Re: Green Eagle Railroad, LLC
– Construction and Operation of a Line of Railroad – In Maverick County, TX
Surface Transportation Board Finance Docket 36652

Supplement to Information Request: Floodplain Requirements and Specifications
of the Sound Barrier

Green Eagle Railroad Project
Preliminary Engineering

Northern Alignment - Proposed railroad equipment and infrastructure

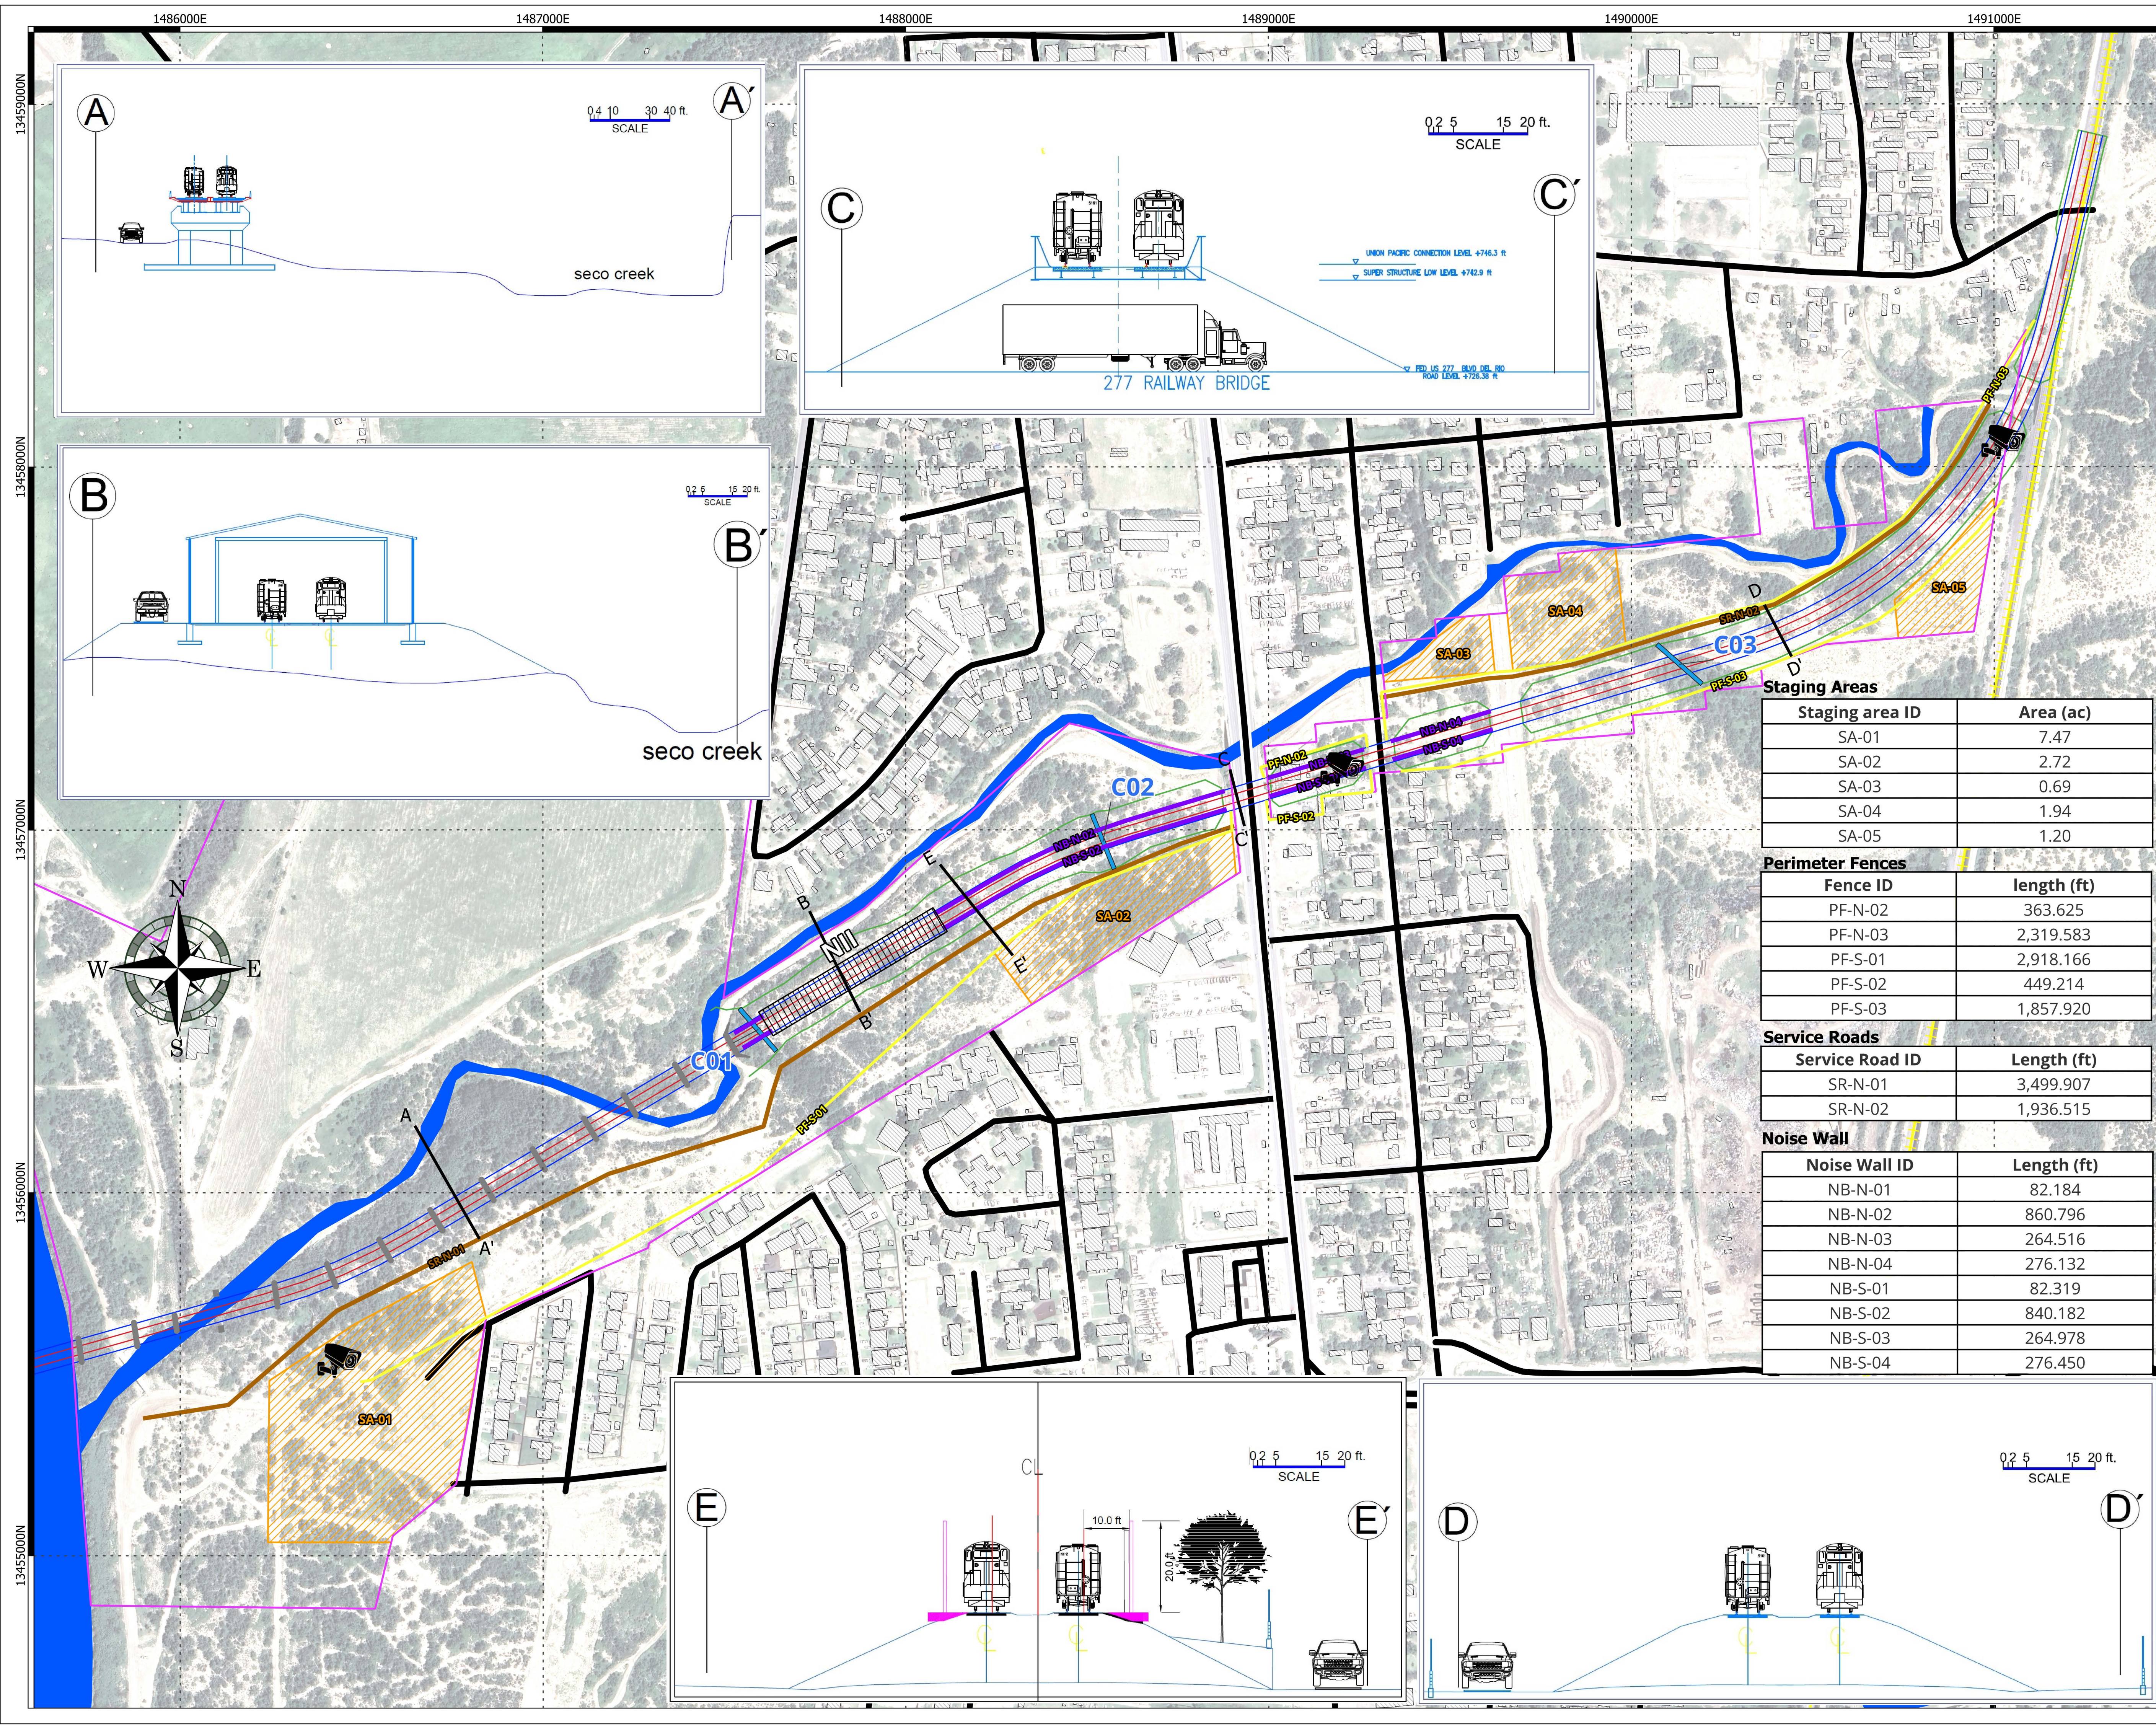
Previous maps of the GER sound barriers included barriers over bridges (on the Proposed Line and the Northern Alternative). Following a comprehensive review and structural analysis, GER has determined that the inclusion of the sound barriers over bridges (for example, spanning Del Rio Blvd. and Barrera St.) would present significant challenges in meeting the required performance standards for those bridges. The primary concerns are the added weight and wind loads imposed by the sound barriers, which would exert considerable strain on the structural components of the bridges and would make the engineering particularly challenging and potentially cost prohibitive. In GER's view, the safety benefit of excluding the noise barrier on these bridges outweighs the potential noise reduction benefit of constructing a sound barrier on the bridged portions. The enclosed maps provide GER's sound barriers, revising the location of these barriers to exclude the portions of the rail line that would be built upon a bridge.
